BT-01-2013 EUROCOPTER ECUREUIL AS350B3

ASUNTO: ROTOR DE COLA - HUB - ROTOR DE COLA (TRH) CUERNO PITCH LIMITES CONTROLES DE MANTENIMIENTO Y TIEMPO

**ALERT SERVICE BULLETIN
350 05.00.74**

SUBJECT: TIME LIMITS/MAINTENANCE CHECKS - TAIL ROTOR - Tail Rotor Hub (TRH) pitch horn

Figure 1: Areas to be checked for cracks

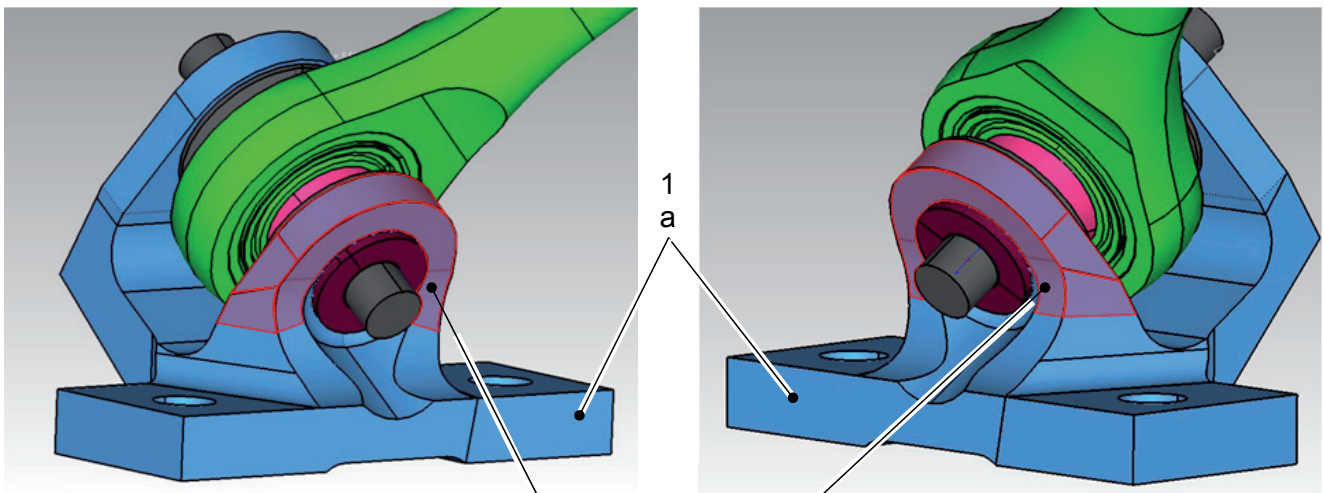
Visually check that there are no cracks on the inner yoke of the two TRH pitch horns (a) (Figure 1, DETAIL A and B). If in doubt, carry out a dye-penetrant test.

- case 1: no cracks detected on the two TRH pitch horns: leave as is and proceed with the final steps as per paragraph 3.B.3.
- case 2: at least one crack detected on the TRH pitch horn: remove and replace the incriminated horn as per paragraph 3.B.2.b. before resuming flights.

- Remove the TRH pitch horn (a) as per MRM Work Card 64.10.00.707 or AMM Task 64-10-00,8-2.
- Install the TRH pitch horn (1) as per MRM Work Card 64.10.00.707 or AMM Task 64-10-00,8-2.
